BLUE RIVER PLANNING AND ZONING COMMISSION MEETING FEBRUARY 2024

TO: Michelle Eddy, CMC/CPM - Town Manager/Clerk
FROM: Kyle Parag, Plan Reviewer - CAA
DATE: January 31st 2025
RE: Planning/Zoning/Architectural Guidelines review – 0266 Davis Ct

TO: Michelle Eddy, CMC/CPM - Town Manager/Clerk
FROM: Kyle Parag, Plan Reviewer - CAA
DATE: January 31st 2025
RE: Planning/Zoning/Architectural Guidelines review – 0189 Gold Nugget Dr

A3.1

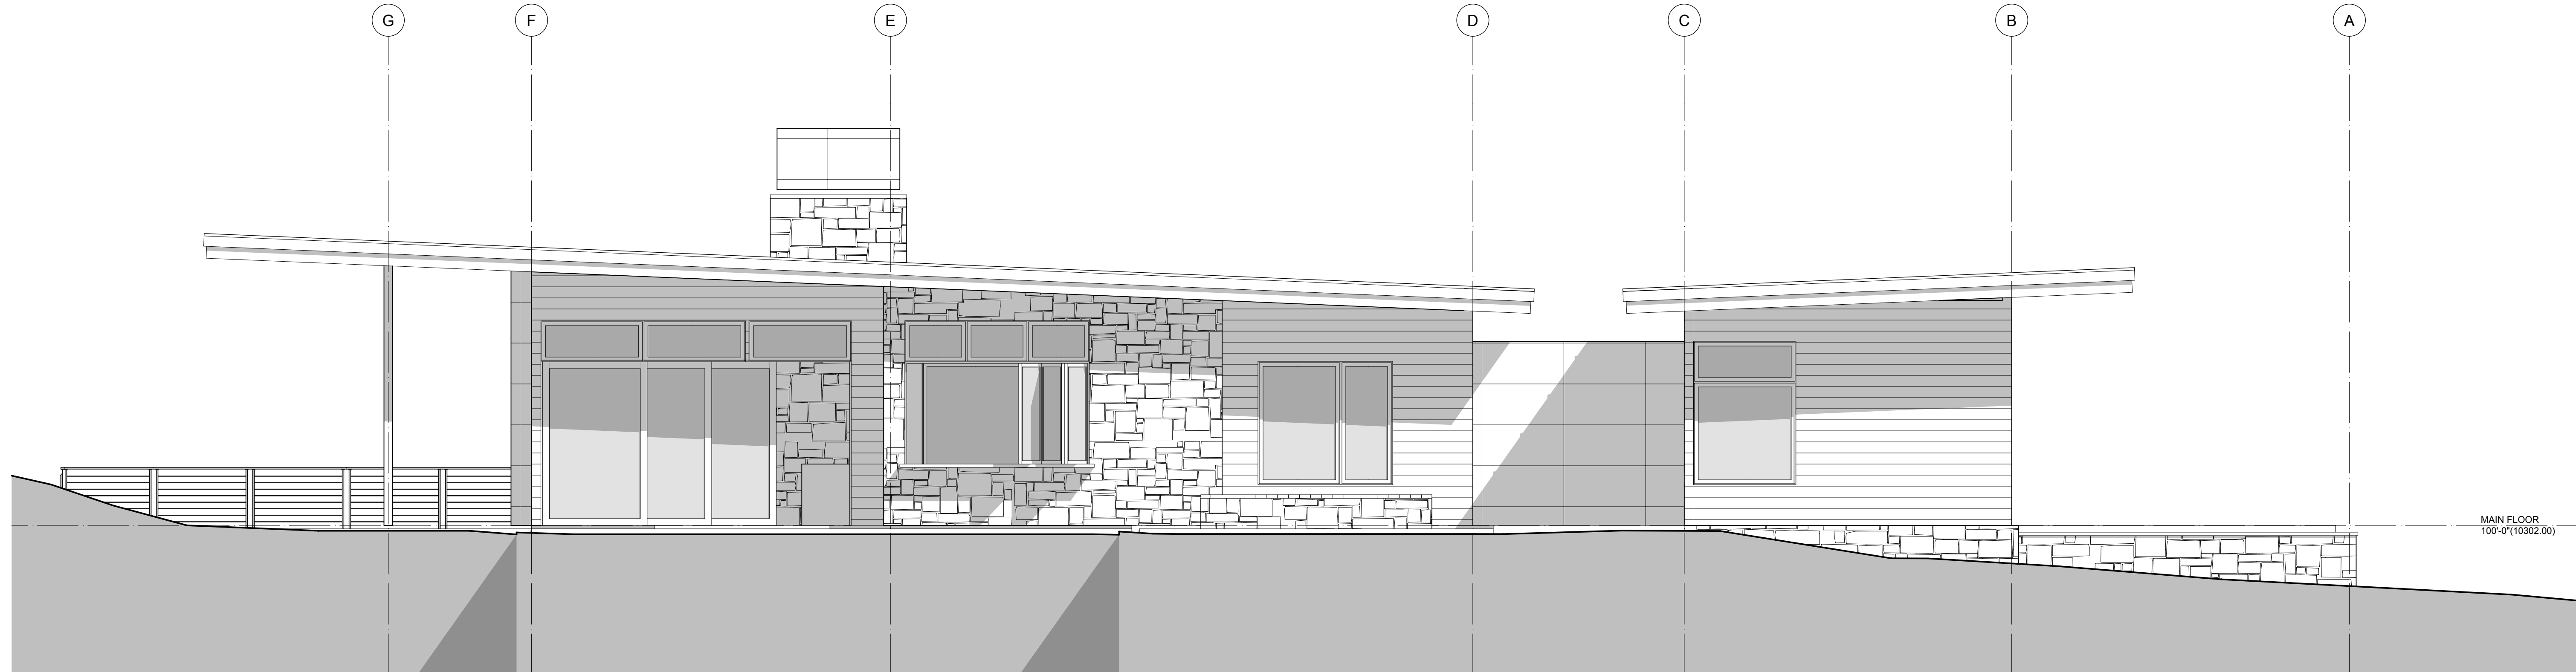
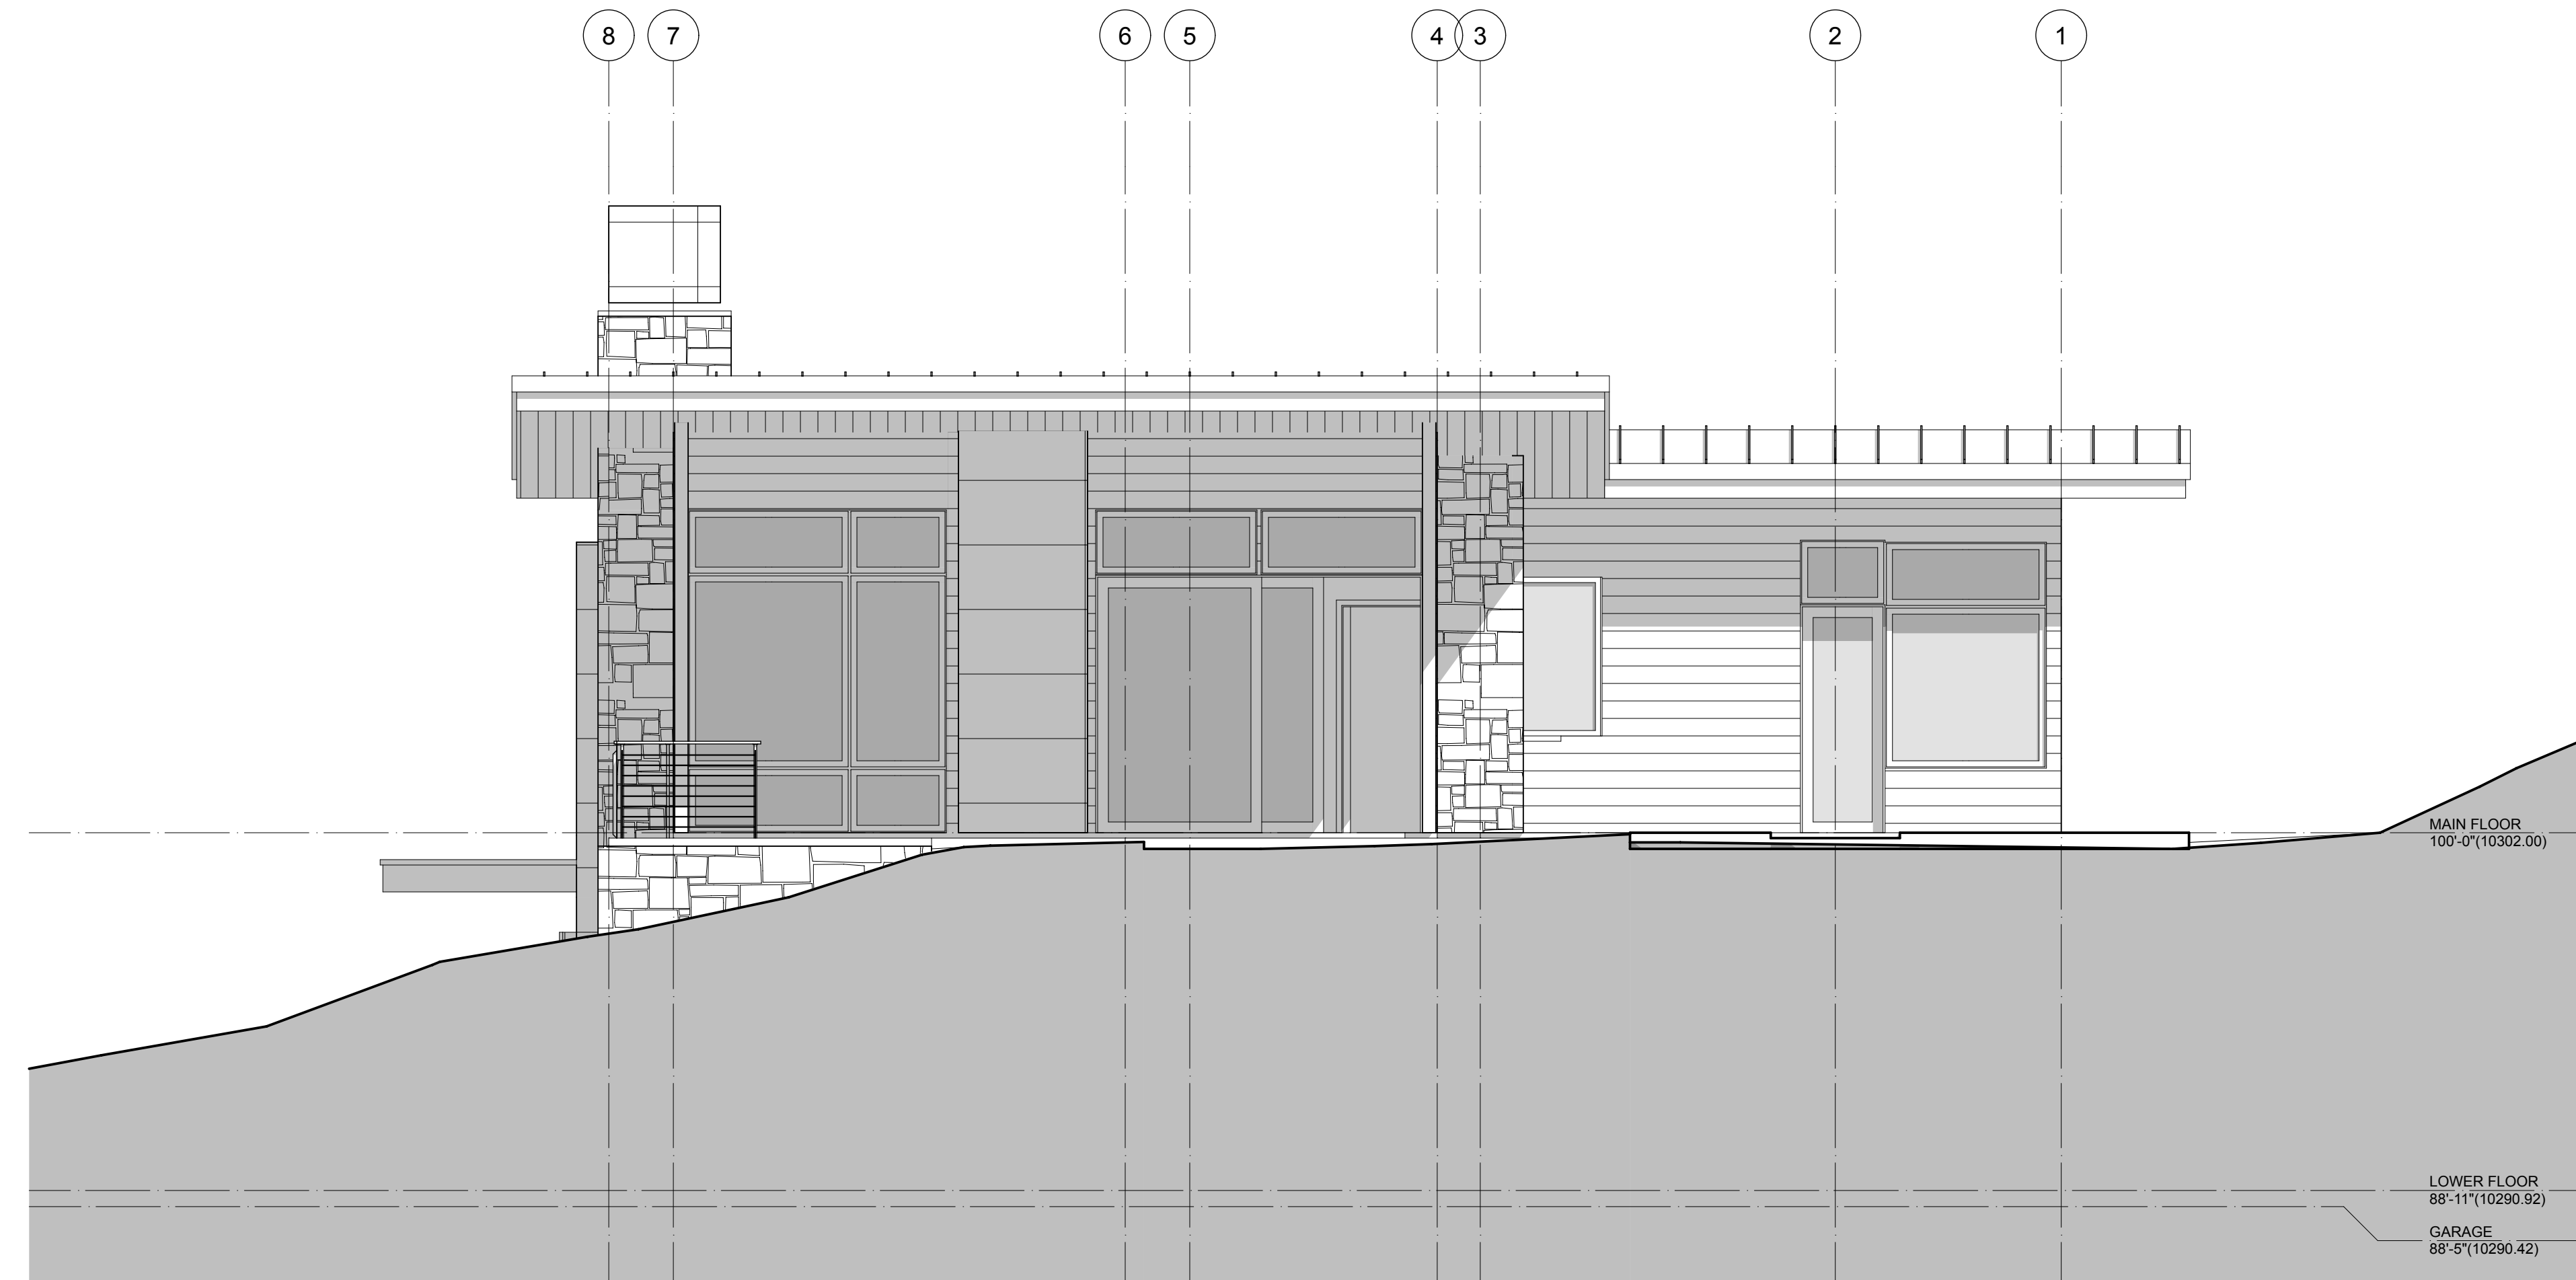
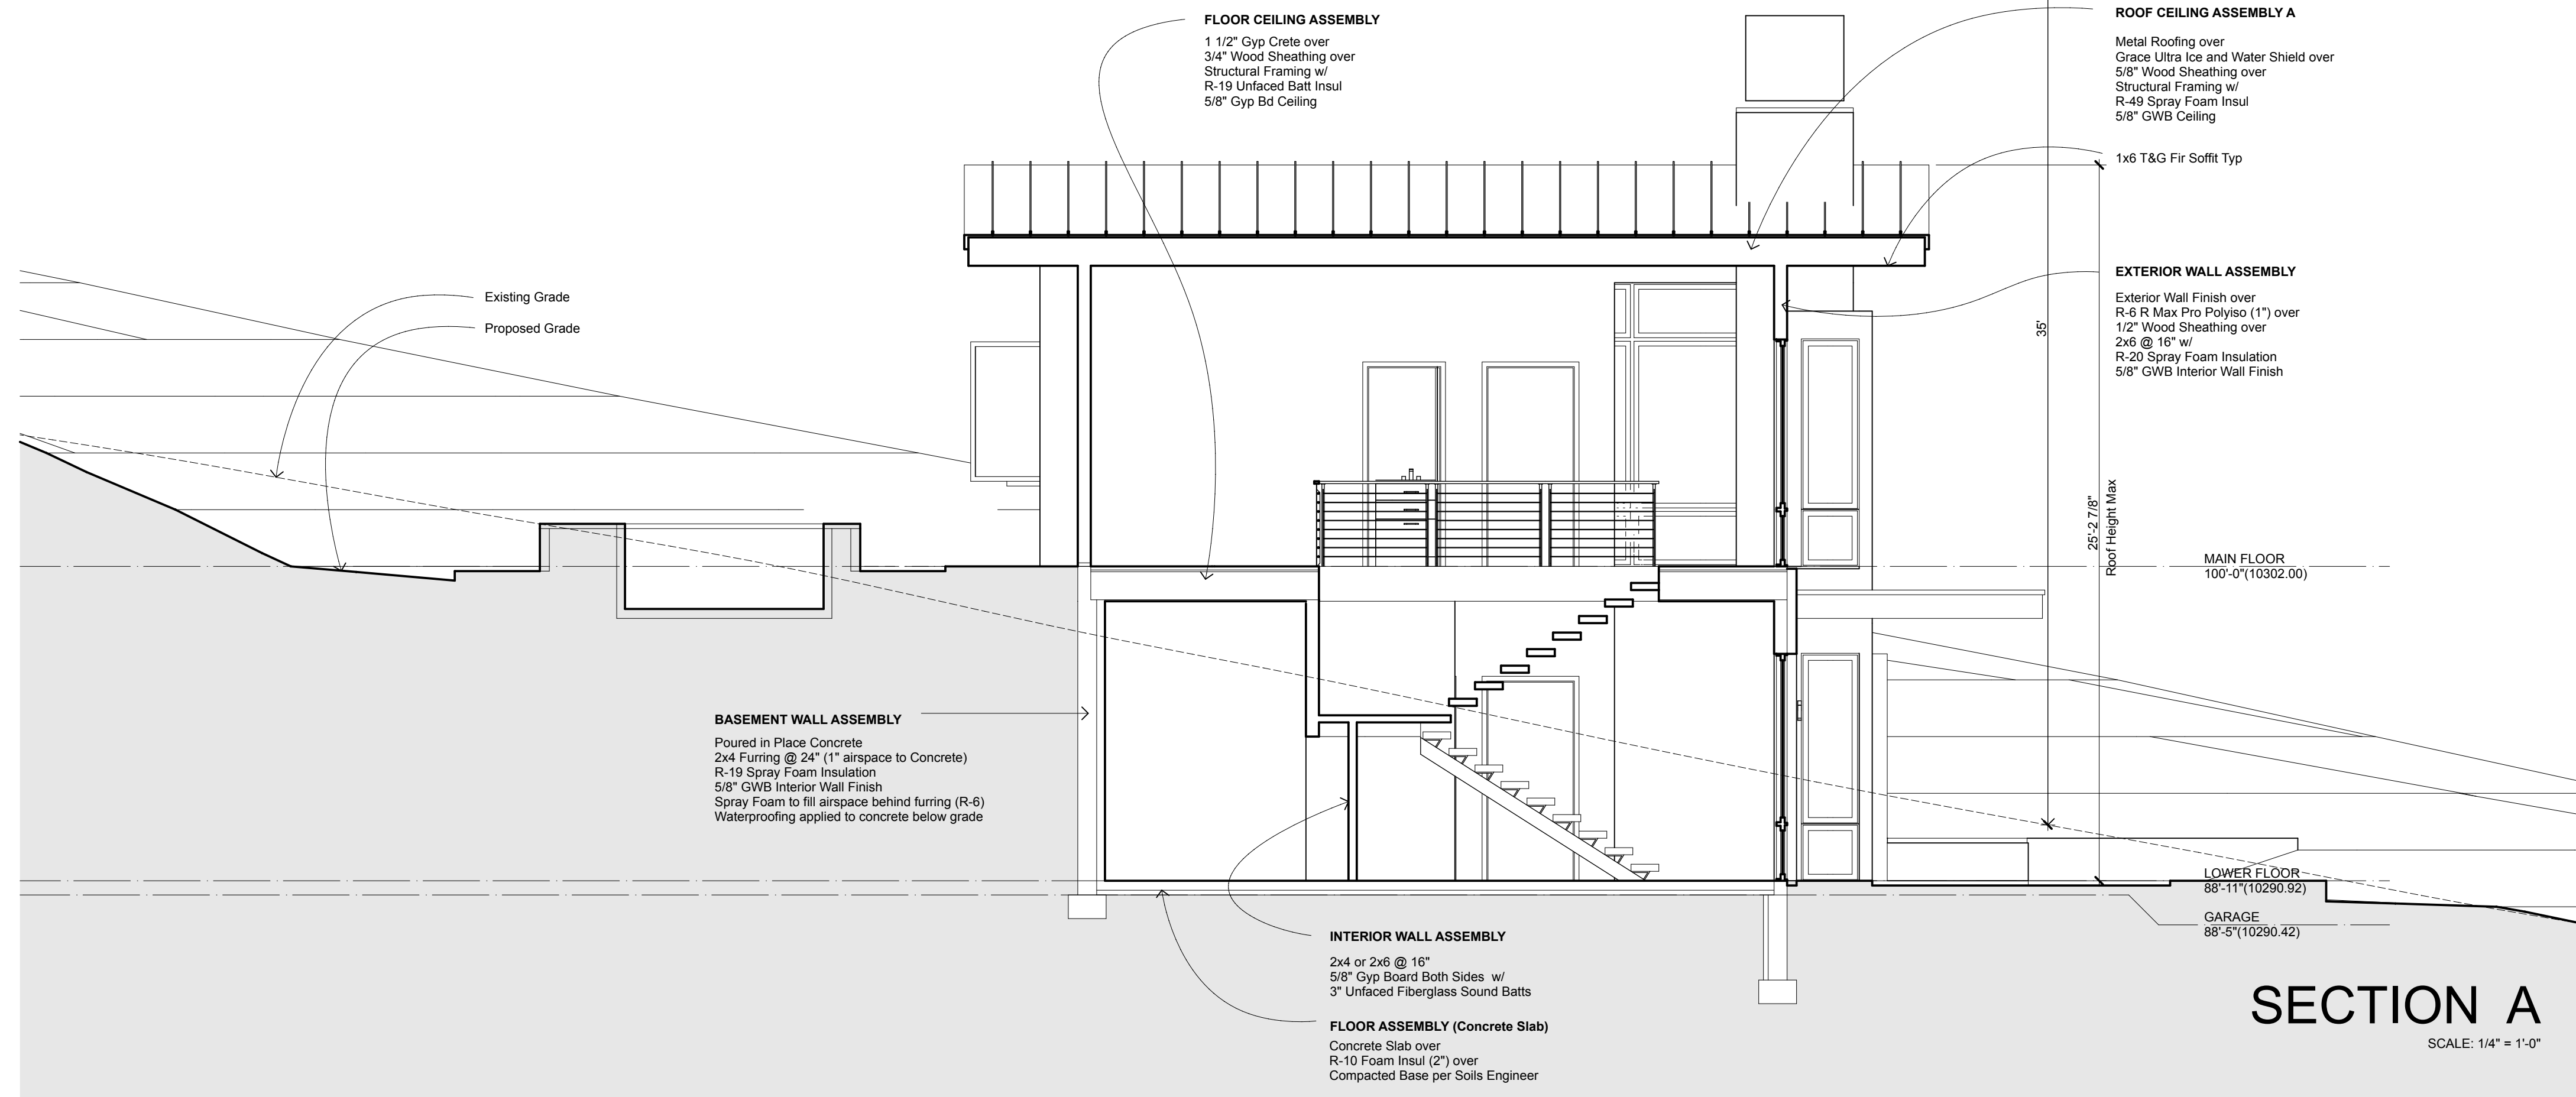
Balconies and railings		
Article 5-110 Chimney and Roof Penetrations	Chimney is indicate with stone and prefinished metal panels for a cap. Chimney is large.	Y
Article 6 Building Materials and Colors		
Article 6-20 Materials	materials are stone and metal panels.	PC
Article 6-30 Colors	Colors are provided and show general compliance	Y
Article 7 Accessory Improvements		
Article 7-(20-40, 110) Berms, Garages, sheds and Gazebos	None indicated. Garage is indicated at 757 Sqft	Y
Article 7-50 Driveways	Width indicated at 12'. Slopes are indicated at 8%	Y
Article 7-60 Parking Areas	Exterior parking space complies.	Y
Article 7-100 Decks	No deck is indicated, but an outdoor patio with retaining walls is indicated on the rear of the home, and shows general conformance.	Y
Article 7-120 Hot Tubs	Located at rear of home.	Y
Article 7-140 Fences	None indicate	Y
Article 7-150 Retaining walls	Long retaining walls are indicated along the top edge of the driveway. The walls are proposed as stone look (silom Stone). The retaining wall is located in the setback, which is not permitted in (1)(i) unless necessary.	PC
